UNITED STATES OF AMERICA
NUCLEAR REGULATORY COMMISSION

Docket No. 50-361

Amendment Application
No. 98

DESCRIPTION AND SAFETY ANALYSIS
PROPOSED LICENSE AMENDMENT TO USE THE SHUTDOWN COOLING
SYSTEM AS A PRIMARY MEANS OF COOLING THE SPENT FUEL POOL
SAN ONOFRE NUCLEAR GENERATING STATION, UNITS 2 AND 3

FIGURE 1

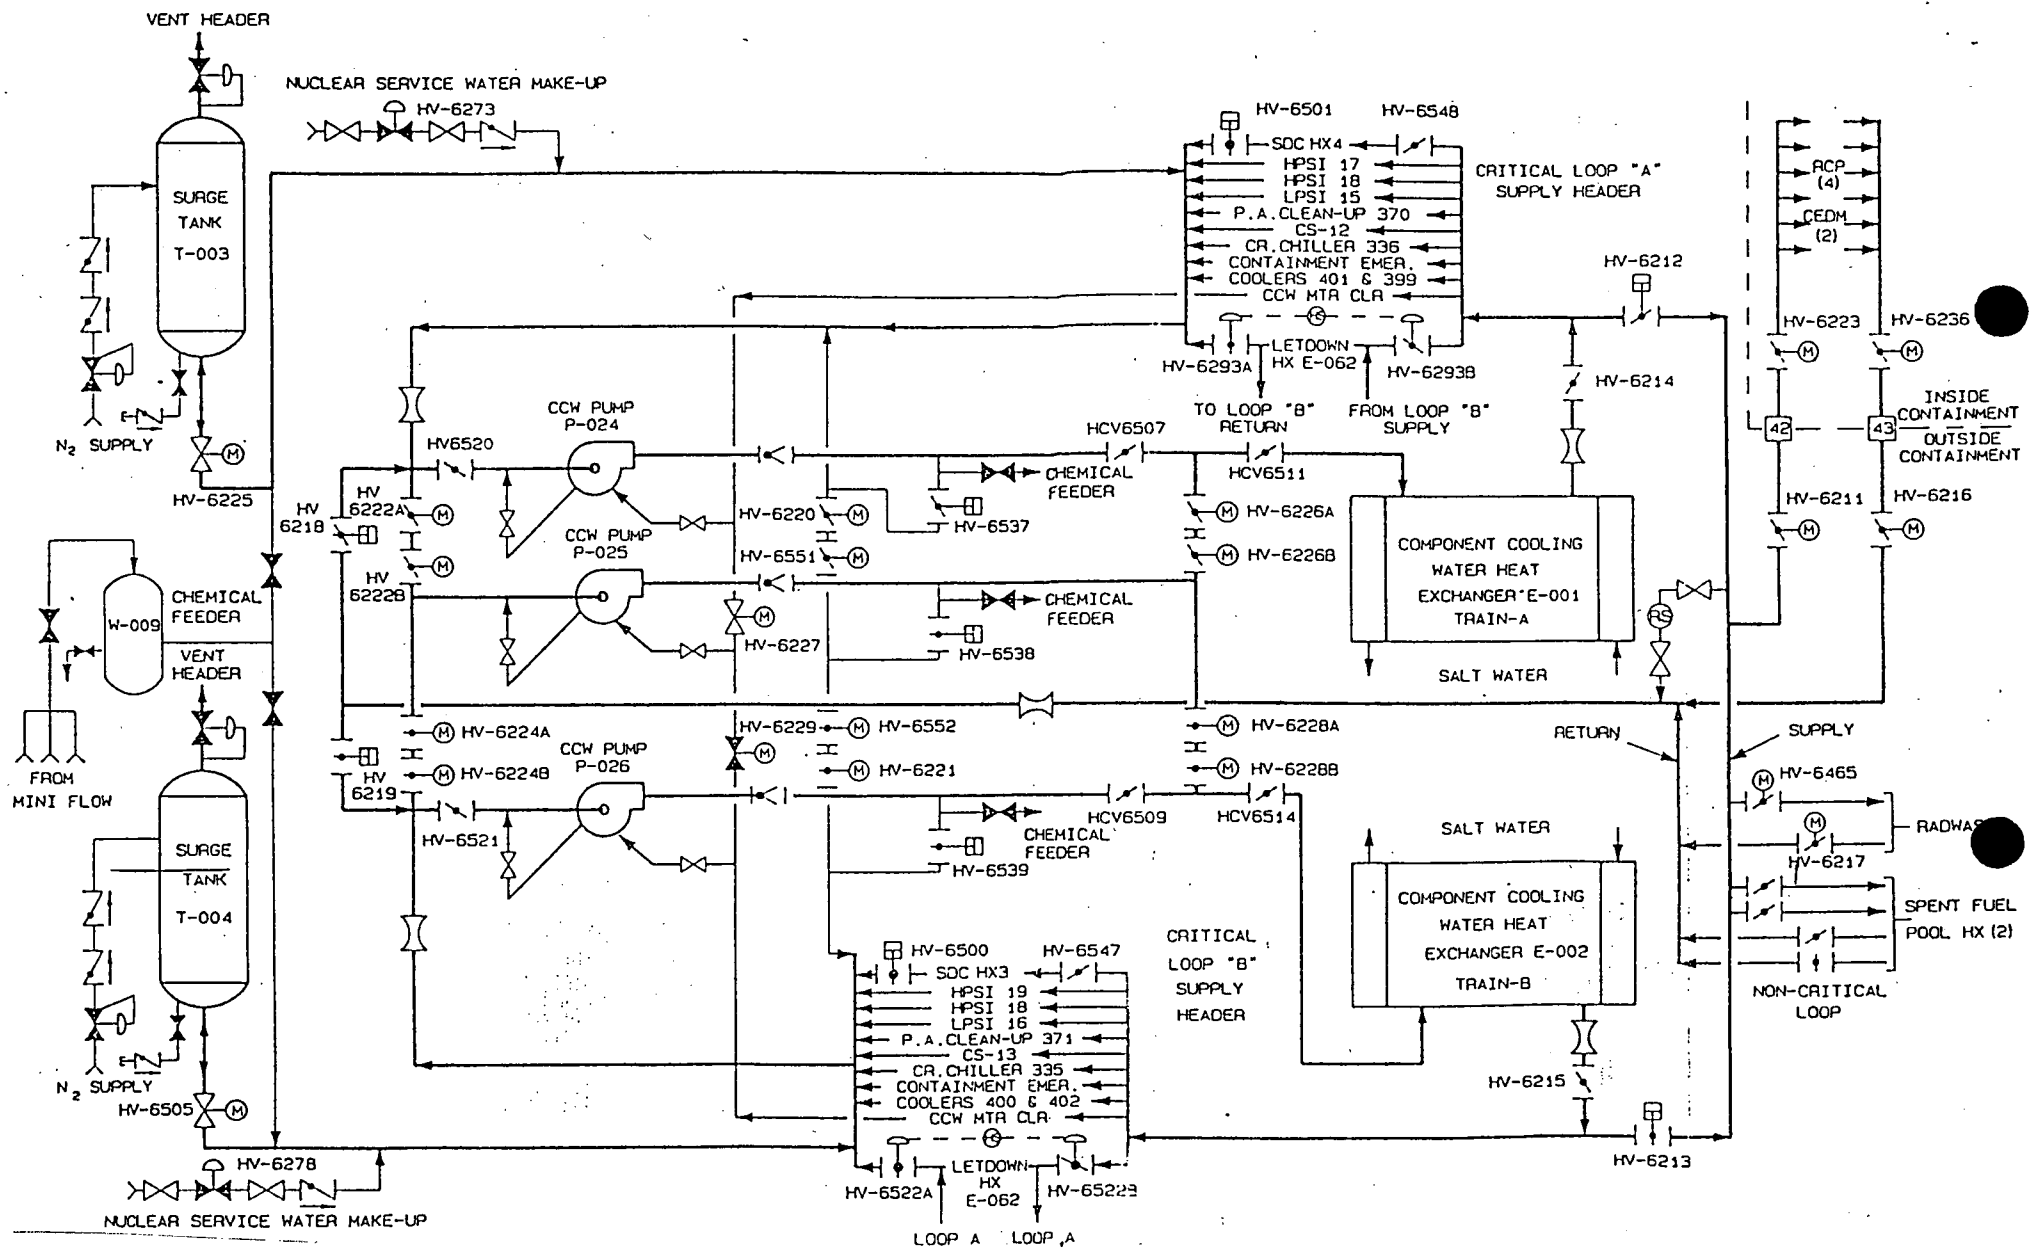
The CCW system has two 100 percent capacity train aligned pumps and one 100 percent capacity swing pump, each powered from the class 1E electrical system, and two 100 percent capacity heat exchangers. The two independent critical loops are interconnected with a cross tie downstream of the heat exchangers and a cross tie upstream of the component cooling water pumps. Isolation valves for the two independent critical loops are provided in these two cross ties. The non-critical loop piping is connected between these cross ties such that it can be supplied from either critical loop. Each CCW critical loop operates independently of the other including when the opposite loop cross train isolation valves are isolated for maintenance. The piping configuration for cross train isolation valves HV-6212, -6213, -6218, -6219, and the non-critical loop is shown in Figure 1.

- a. One train of CCW must be isolated and taken out of service,
- b. The non-critical CCW loop, which provides normal cooling to the SFP, must be isolated and taken out of service, and
- c. Alternate cooling must be provided for the spent fuel pool.

Using the SDC system to cool the SFP will allow either train of CCW to be isolated and the non-critical CCW loop to be isolated and taken out of service, which, in combination, permit maintenance to be performed on the CCW train isolation valves. This will also allow maintenance on portions of the SFP cooling system that are not used by the SDC system when aligned to cool the SFP.

FIGURE 2

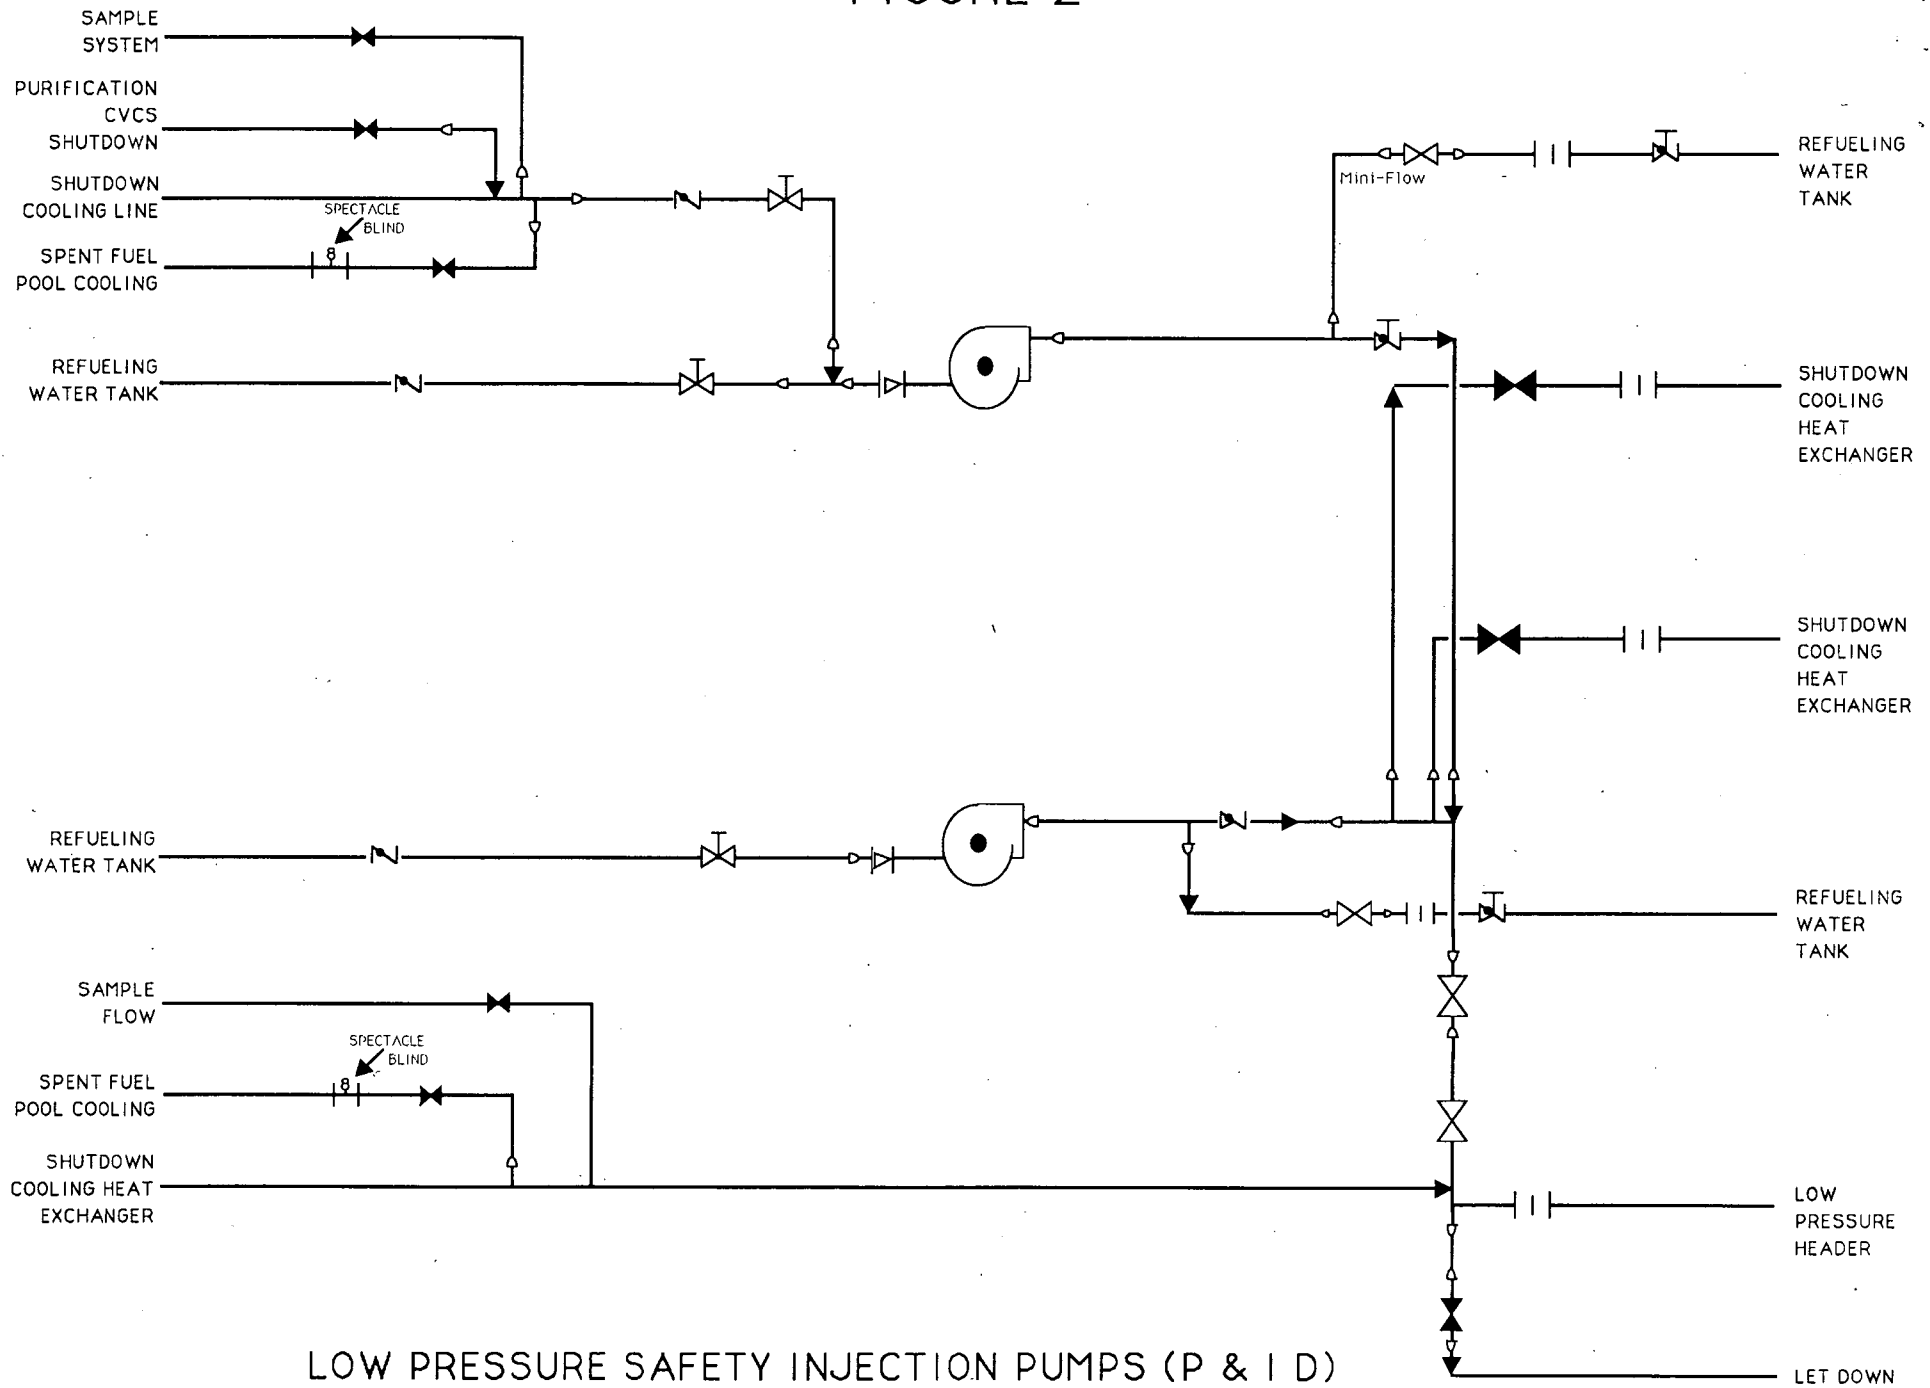
The SDC system has two 100 percent capacity heat exchangers, each cooled by a CCW critical loop. Flow through the SDC heat exchangers is provided by two low pressure safety injection pumps; each pump can be aligned to either SDC heat exchanger. The system can be aligned to recirculate either the reactor coolant system or the SFP. The process generally consists of the reversal of blind spectacle flanges, a fill and vent of the suction and discharge lines from the refueling water storage tank, and a valve alignment. This procedure will require several shifts to complete. The piping configuration for the blind spectacle flanges and the low pressure safety injection (LPSI) pumps is shown in Figure 2. The LPSI pumps and the SDC heat exchangers are shown in Figure 2A.

- a. Each SDC train is cooled by a corresponding CCW train.
- b. Existing spectacle blind flanges may be used to align the SDC system to the SFP.
- c. SDC is not needed to comply with any Technical Specification requirements during a full core offload.

The shutdown cooling system is a safety related, seismically qualified system which is powered by a class 1E electrical system. The cooling capacity of 1 train of the shutdown cooling system is sufficient to maintain the spent fuel pool temperature lower than the spent fuel pool cooling system. During a full core offload from the reactor vessel the shutdown cooling system is not required to be operable for

reactor core cooling. The shutdown cooling system (consisting of 1 LPSI pump, 1 heat exchanger, Flow Path to and from the SFP, and the associated Diesel Generator) may be aligned to cool the spent fuel pool.

FIGURE 2A

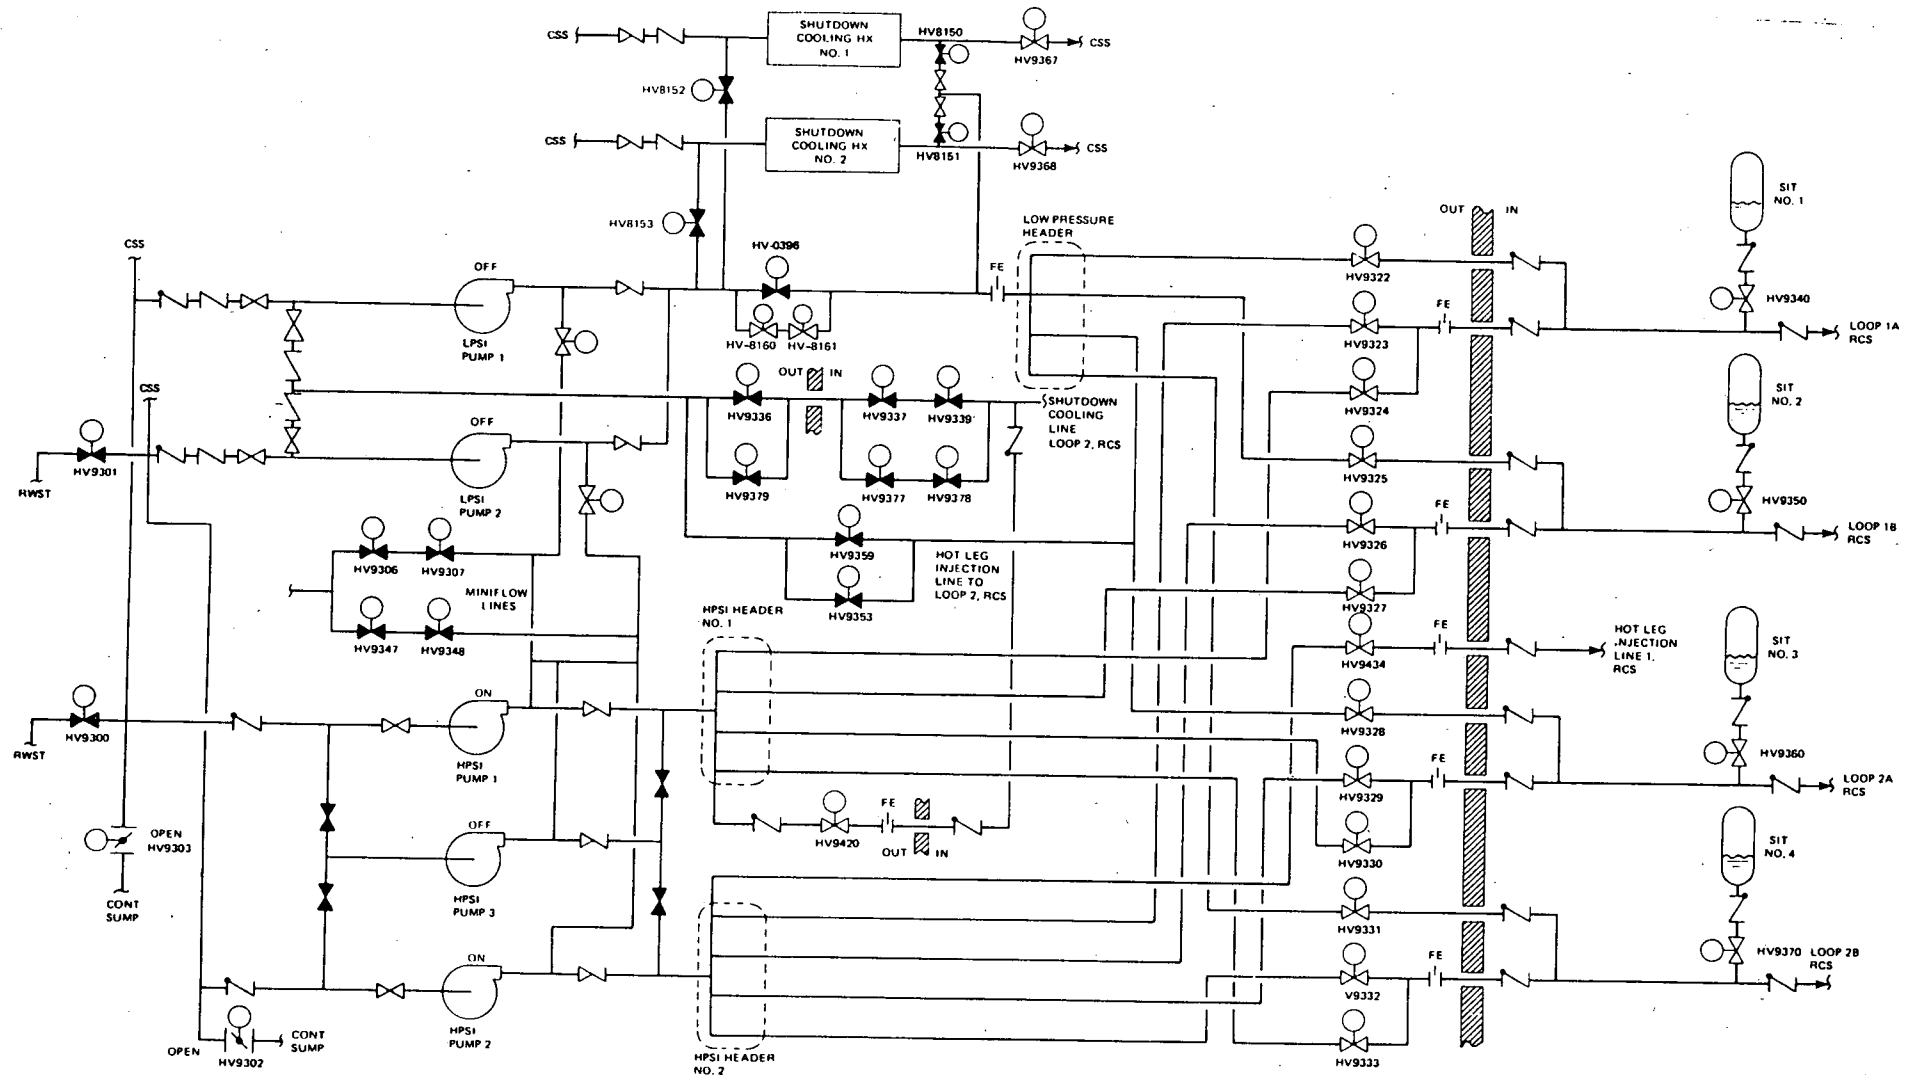
SCE currently takes credit for the SDC system, when it is available, as a backup cooling system for the SFP during complete core offloads. Calculations performed in support of the Units 2 and 3 reracking project show the SDC system (1 pump and 1 heat exchanger) can maintain the SFP temperature approximately 12 degrees cooler than the SFP cooling system (2 pumps and 2 heat exchangers) during a full core offload. Therefore, the function of cooling the SFP is not only maintained but improved.
